**PROPOSED SOCIAL WELFARE FACILITY (RESIDENTIAL CARE HOME FOR PERSONS WITH DISABILITIES) IN "VILLAGE TYPE DEVELOPMENT" ZONE ON APPROVED NAM SANG WAI OUTLINE ZONING PLAN NO. S/YL-NSW/10 AT LOTS 3669 S.A RP (PART), 3669 S.B RP (PART), 3670 RP (PART) AND ADJOINING GOVERNMENT LAND IN D.D.104, NAM SANG WAI, YUEN LONG**

**Town Planning Application No. A/YL-NSW/348 - Submission of Further Information (2)**

**Response-to-Comment Table**

Proposed demolished portion street furniture (planter), approximately 13.8m in length

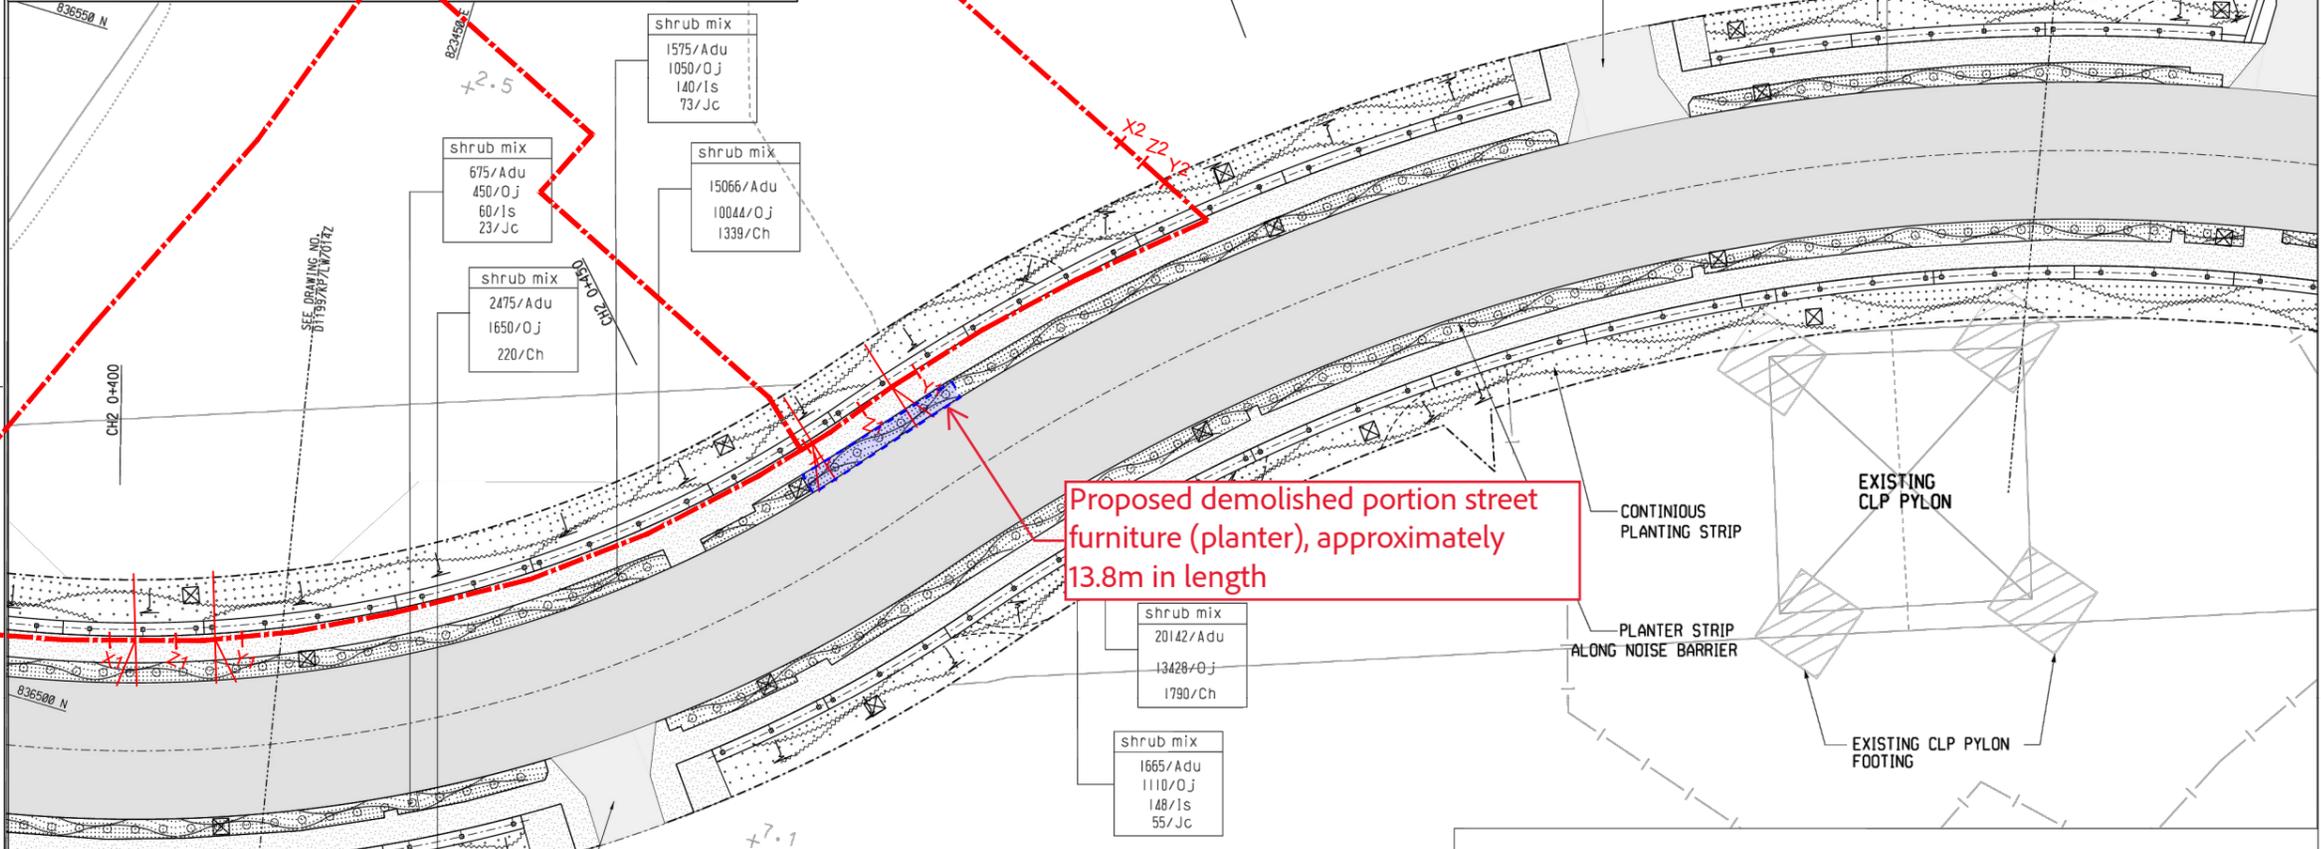
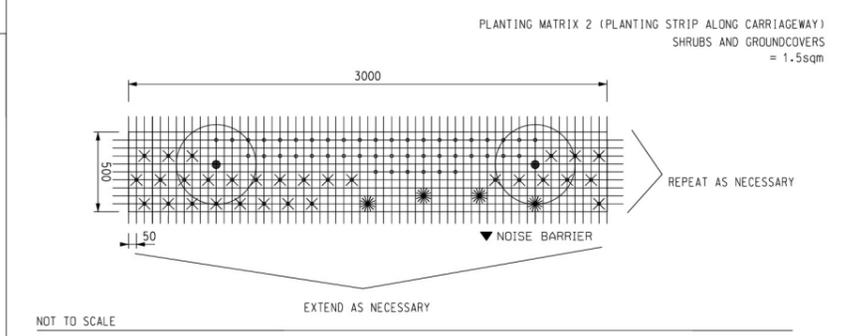
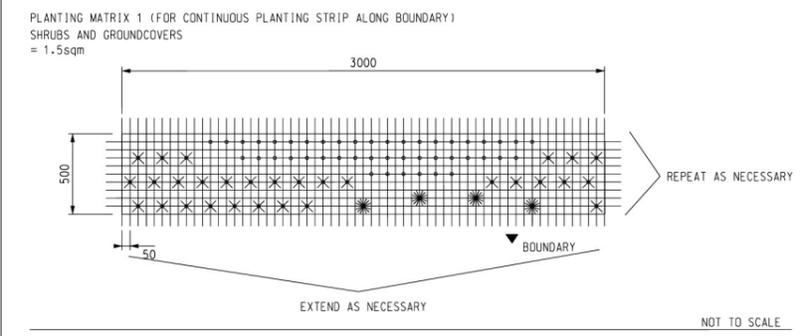
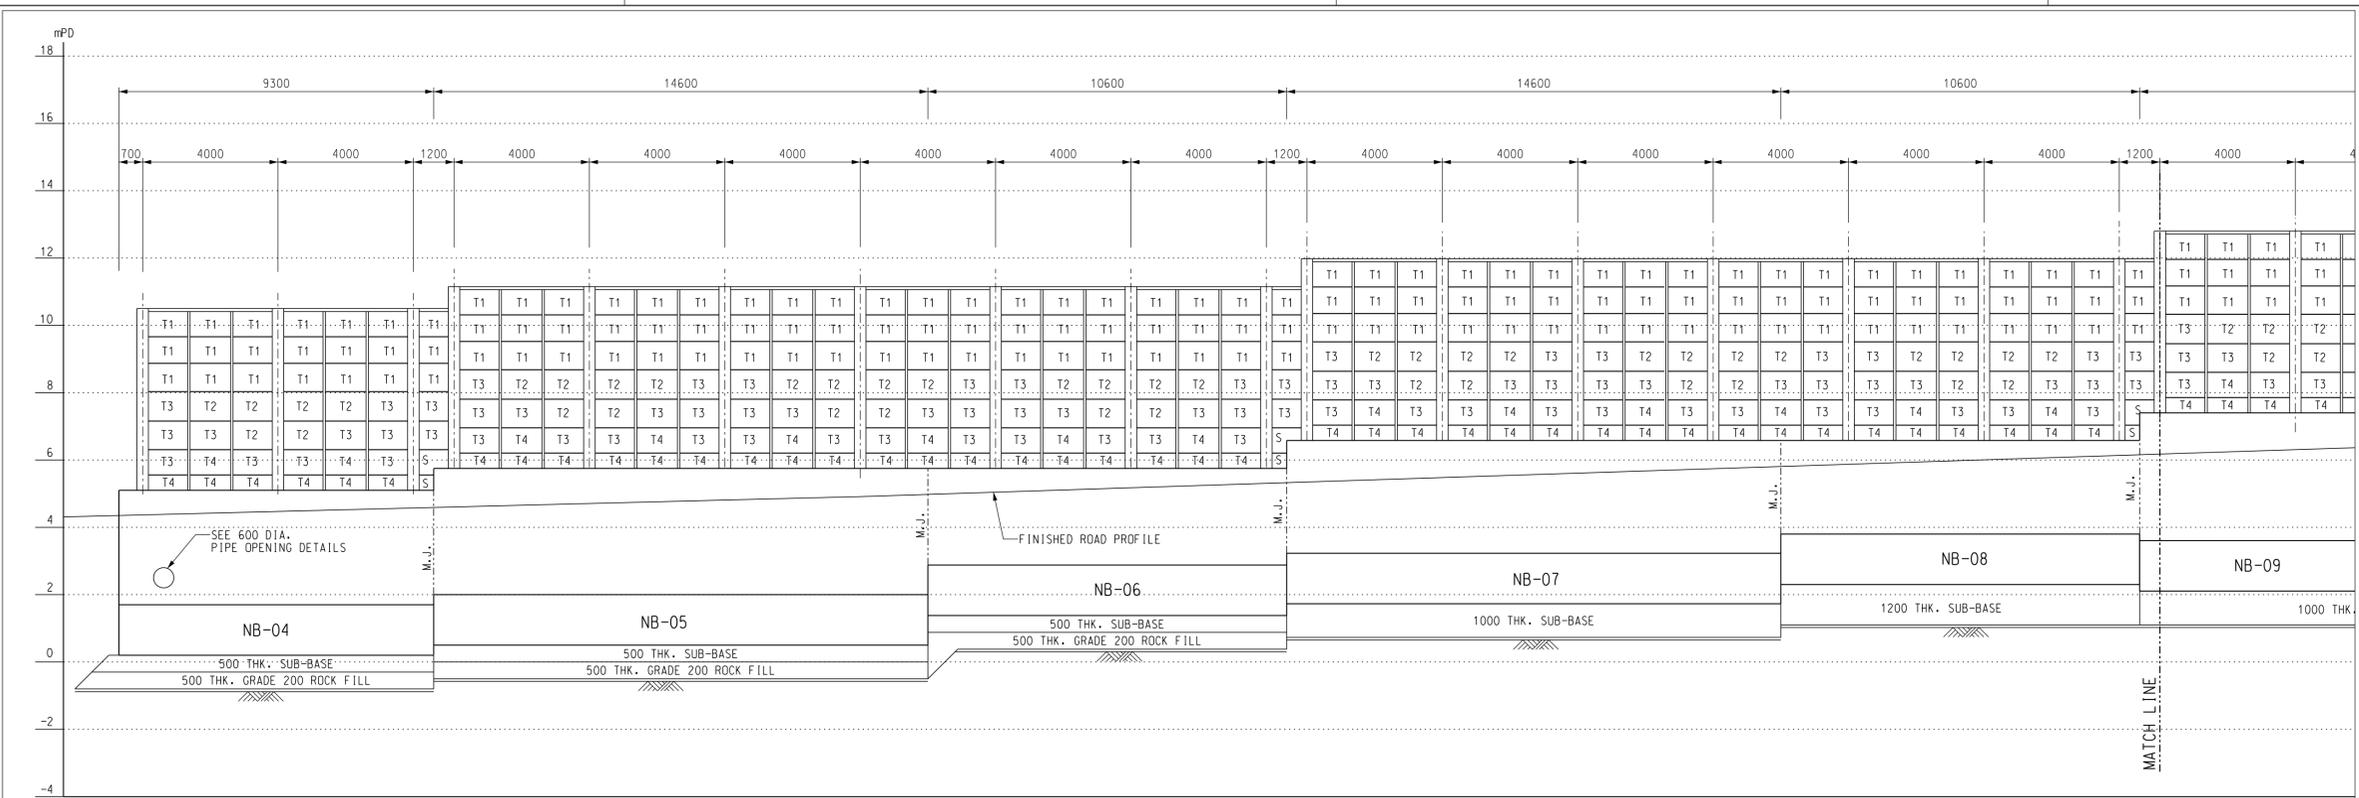
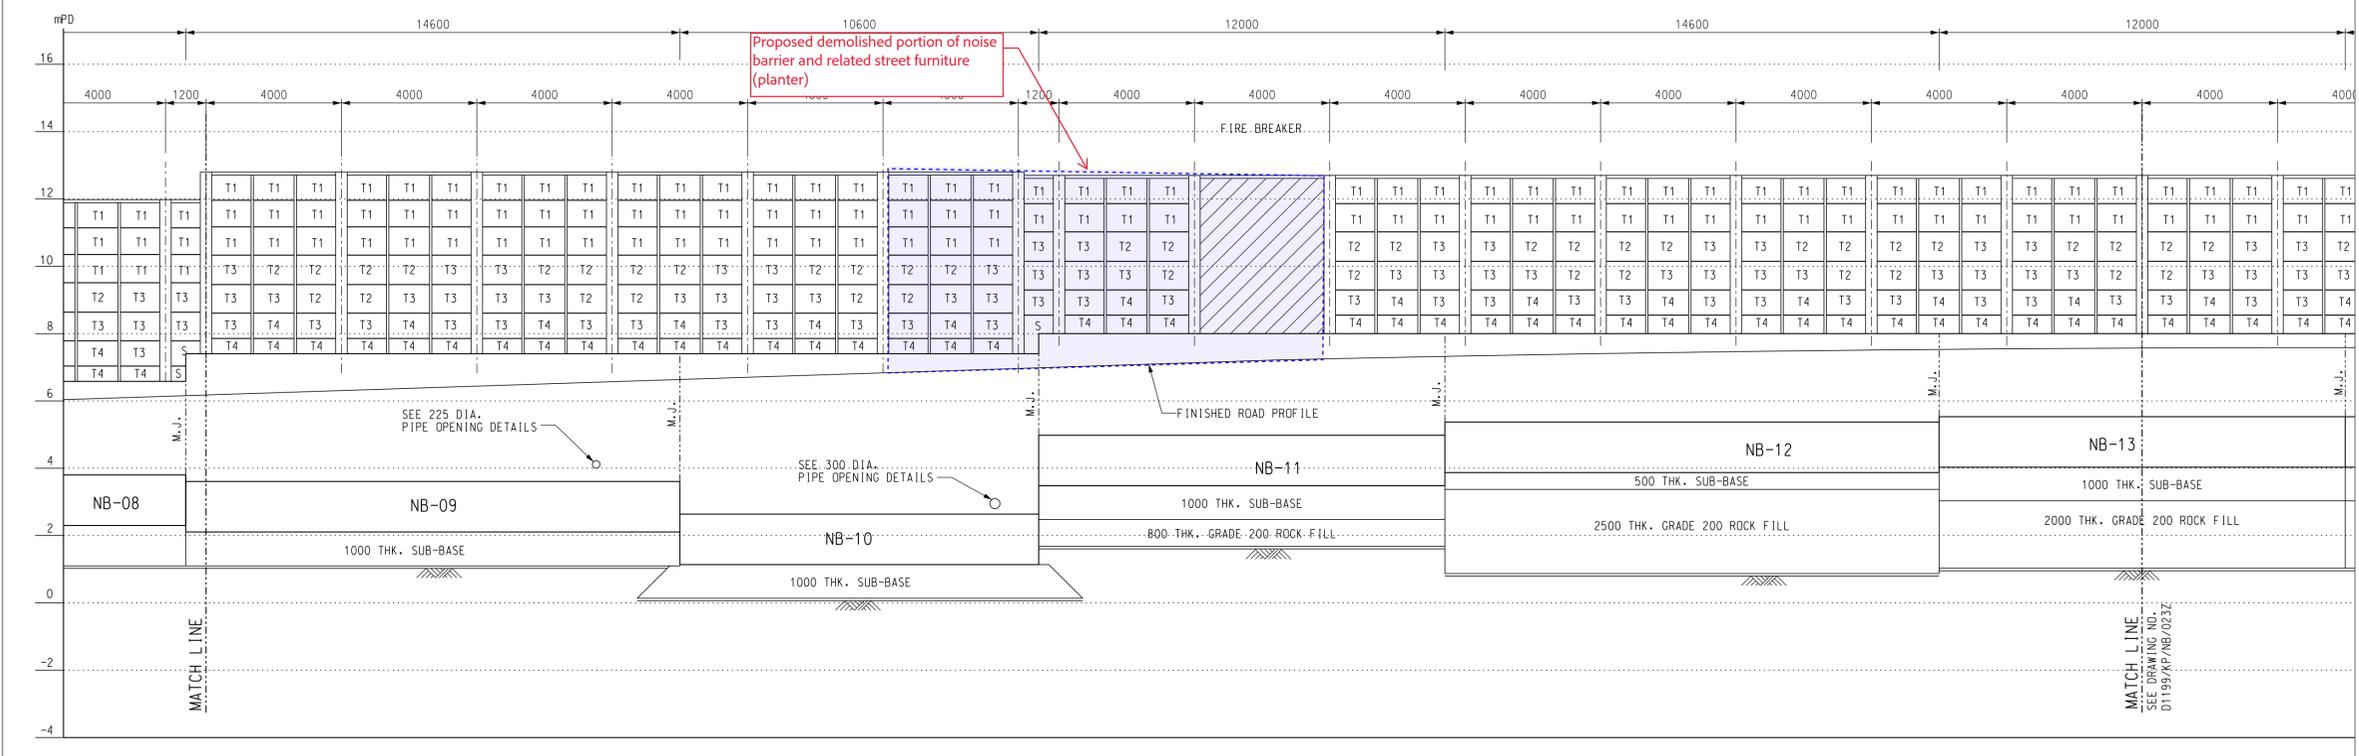
16. There are noise barriers positioned at the proposed site access. Please provide details on the site access arrangement;	Portion of the existing noise barriers and related street furniture (planter) will be demolished for the proposed site access. Please refer to Appendix 3 for the proposed alterations.

2. It is noted that there are existing noise barriers under HyD's maintenance purview at the south-east boundary of the site, adjoining Kam Pok Road East. Please advise if there are any modification or alteration of the noise barriers among other road features (e.g. the existing footpath/ carriageway adjoining the site) be required arising from the proposed development.	Please refer to Appendix 3 for the Modification Plans of Noise Barrier and Street Furniture.
